MILLS FAMILY DIVISION SUBDIVISION

APPLICATION NUMBER 1 DATE October 2, 2014

DETAIL SITE PLAN

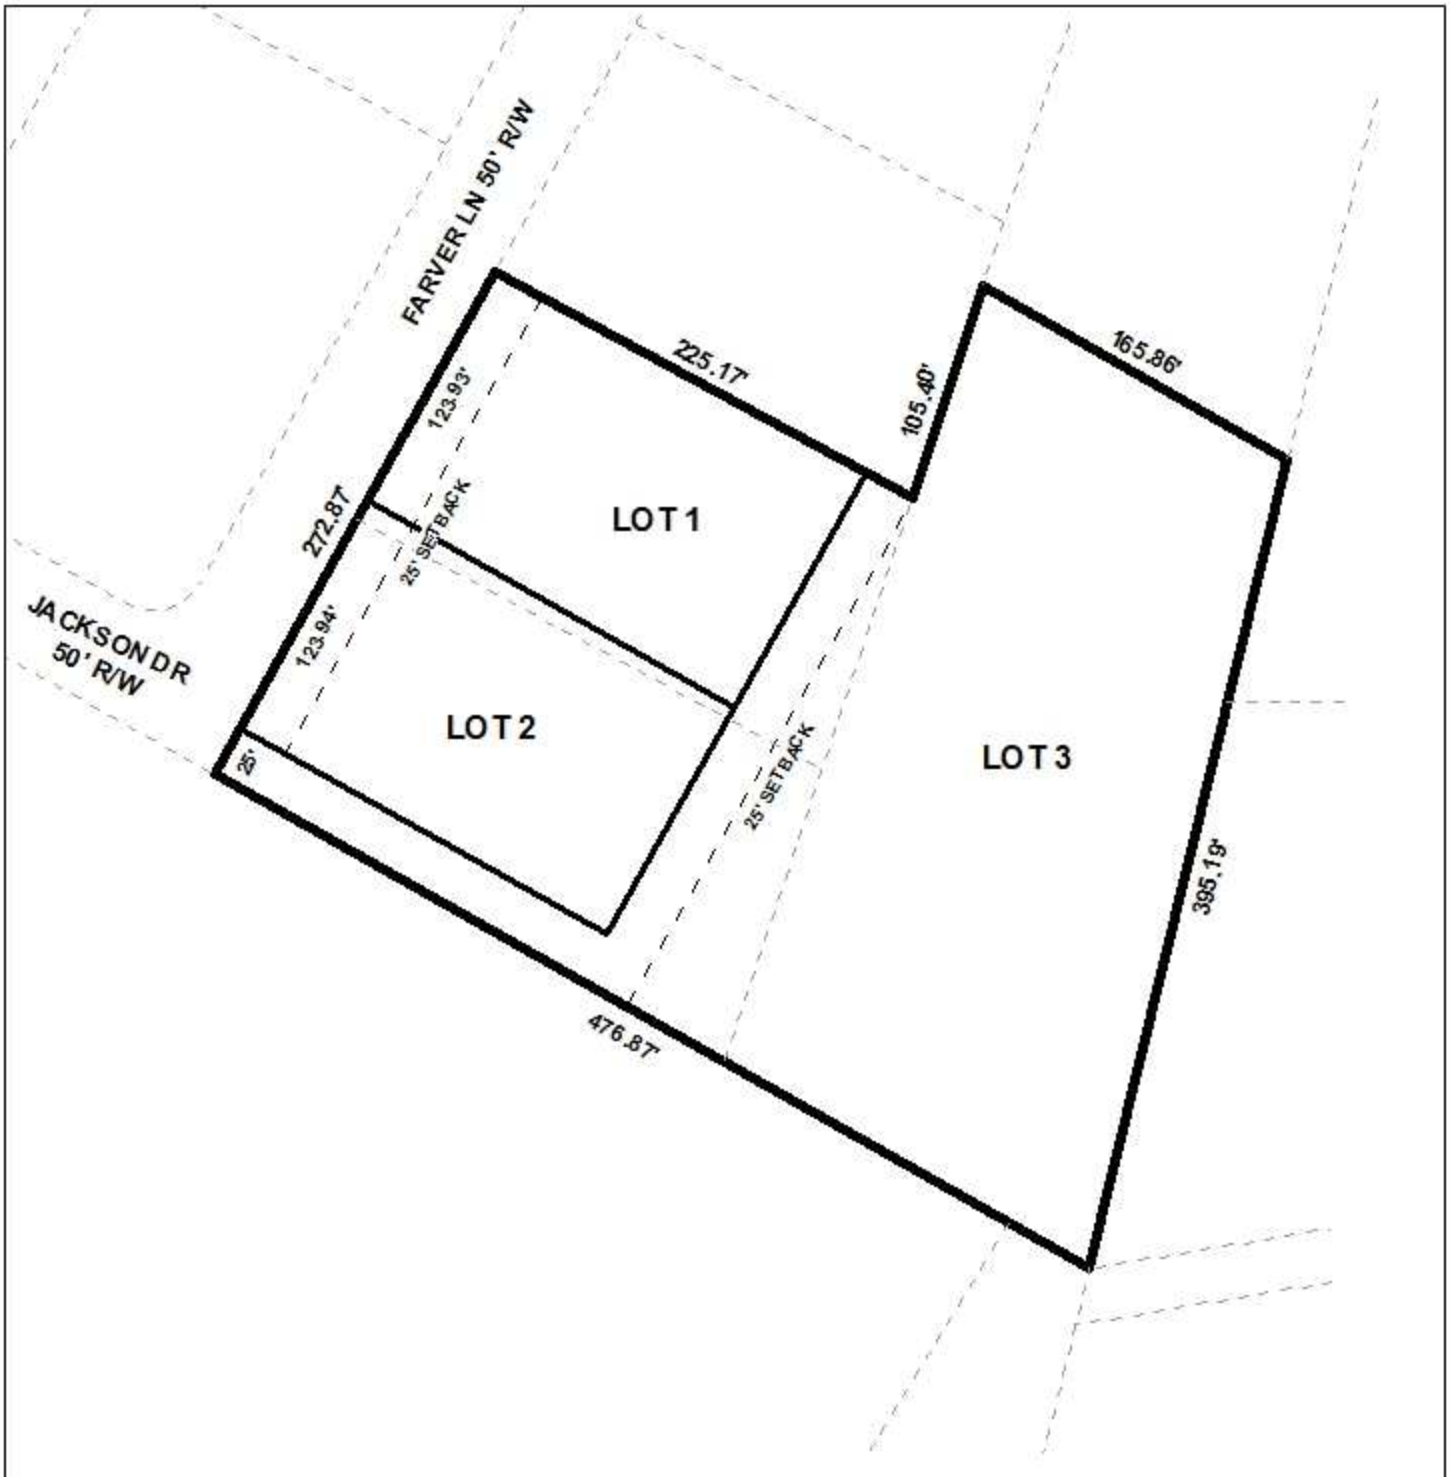
The proposed lots have frontage along Farver Lane, a minor street without curb and gutter. The preliminary plat submitted indicates that Farver Lane has a current 50' right-of-way. A 60' right-of-way would normally be required for a street without curb and gutter; however, Lots 1 and 2 are apart of the previously recorded Sherbrook Subdivision with an approved 50' right-of-way. Thus no dedication should be required.

The 25' minimum building setback is shown on the plat, and should be placed on the Final Plat, if approved.

As proposed, Lot 3 will be a "flag" lot which is generally discouraged by Section V.D.1. of the Subdivision Regulations. However, they are permitted in those locations where varied and irregularly-shaped lot designs are common, a family division of property, or if the informality of design is consistent with other lots in the vicinity. The applicant has submitted a letter stating the proposed 3 lots will be a family subdivision, which is an additional criteria regarding flag lot requests. There have been several other flag lots allowed by the Planning Commission on Hollingers Island, and this particular subdivision would be similar to others in the vicinity. A waiver of Sections V.D.1. of the Subdivision Regulations will be required. A note should also be placed on the Final Plat stating that no further resubdivision of Lot 3 will be allowed until additional public street frontage is provided.

As a means of access management, a note should be placed on the Final Plat stating that each lot is limited to one curb cut to Farver Lane, with the size, location and design to be approved by County Engineering and conform to AASHTO standards.

As on the preliminary plat, the lots should be labeled with the sizes in square feet and acres on the Final Plat, or a table should be furnished providing the same information, if approved.

It should be noted that the applicant has stated that public water and sanitary sewer is provided; however, comments received from the Mobile Area Water and Sewer System indicate that there is **no** water and sanitary sewer service available at this location. Any proposed lot(s) where there is no public water and sanitary sewer services provided must be a minimum of 40,000 square feet as required by Section V.D.2 of the Subdivision Regulations. Thus Lot 1 and 2 would not meet the minimum size requirements as proposed. This application should be heldover until the October 2nd meeting to allow the discrepancy to be resolved.

- 1. documentation should be provided to indicate if the site is connected to public or private water and sanitary sewer; and*
- 2. a revised preliminary plat should be submitted reducing the number of lots or increasing the lot sizes to comply with Section V.D.2. of the Subdivision Regulations.*
